IMPORTANT BRANDING UPDATE

RYCO BITELOK T200, T400 and T700 SERIES COUPLINGS AND RT200 SERIES INSERTS

T200 example

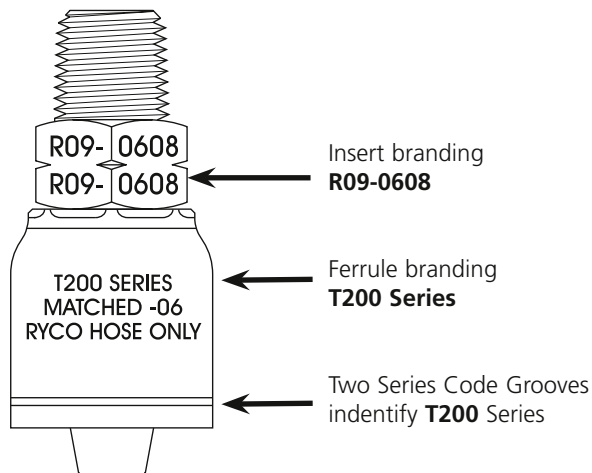
To complete the Part Number for Coupling:
 Insert Part Branding is **R09-0608**
 Series is **T200** (from T200 Ferrule Branding or Two Series Code Grooves)
 Simply replace "**R**" of Insert Part Branding with "**T2**" (first two letters of Series)
(replace R with T2) R09-0608 → T209-0608

T400 example

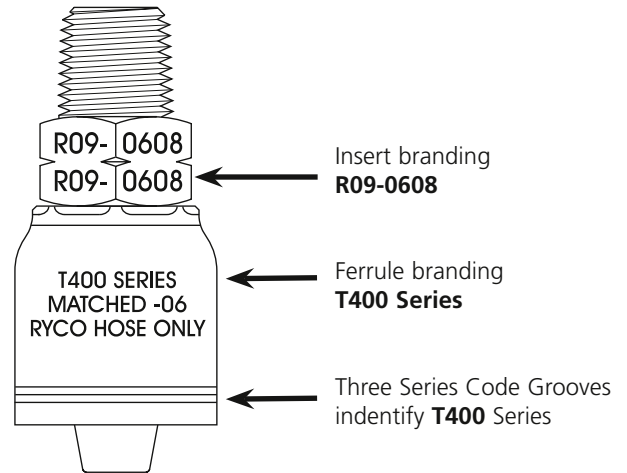
To complete the Part Number for Coupling:
 Insert Part Branding is **R09-0608**
 Series is **T400** (from T400 Ferrule Branding or Three Series Code Grooves)
 Simply replace "**R**" of Insert Part Branding with "**T4**" (first two letters of Series)
(replace R with T4) R09-0608 → T409-0608

T700 example

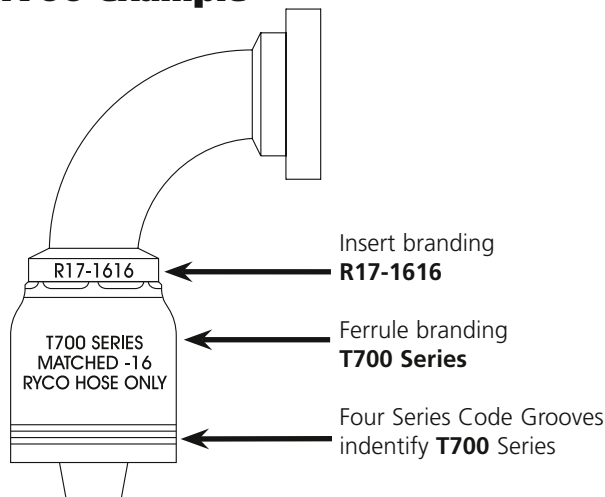
To complete the Part Number for Coupling:
 Insert Part Branding is **R17-1616**
 Series is **T700** (from T700 Ferrule Branding or Four Series Code Grooves)
 Simply replace "**R**" of Insert Part Branding with "**T7**" (first two letters of Series)
(replace R with T7) R17-1616 → T717-1616

RT200 example

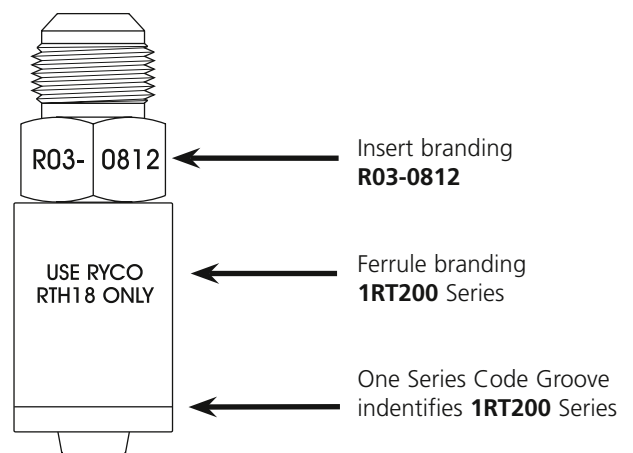
To complete the Part Number for Coupling:
 Insert Part Branding is **R03-0812**
 Series is **1RT200** (from One Series Code Groove)
 Simply replace "**R**" of Insert Part Number with "**1RT2**" (first four letters of Series)
(replace R with 1RT200) R03-0812 → 1RT203-0812

Please note: Part Number for this Insert in current Product Technical Manual is **RT203-0812**
